Access Compliance Report

Public Rights-of-Way

(Pedestrian Signals)

Intersection ID: N/A	Main Street:	Cross Street: N/A	Location: N/A
ADA ID: 78A42CC6E147	Signal Type: One Push Button-APS	Overall Compliance: No	Severity Score: BTN 1: N/A BTN 2: N/A No BTN: N/A
Codes/Mitigation Info/Possible Solution		Field Measurements/Component Compliance

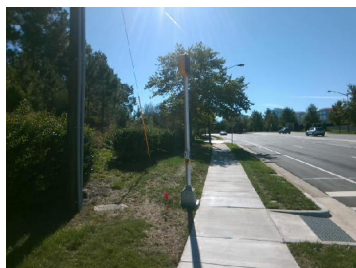
Yes	B 1 Clear Xing Direction?	ClearlyMarked	N/A	B 2 Clear Xing Direction?	N/A
	B 1 Crossing Direction	To W		B 2 Crossing Direction	N/A
Yes	B 1 DistanceTo XWalk (in)	0.0	N/A	B 2 DistanceTo XWalk (in)	N/A
No	B 1 DistanceTo Curb (in)	124.0	N/A	B 2 DistanceTo Curb (in)	N/A
Yes	B 1 Diameter (in)	2.0	N/A	B 2 Diameter (in)	N/A

Possible Solutions: Replace Signal Push Button With APS Button on New Post. Remove & Relocate Sign.
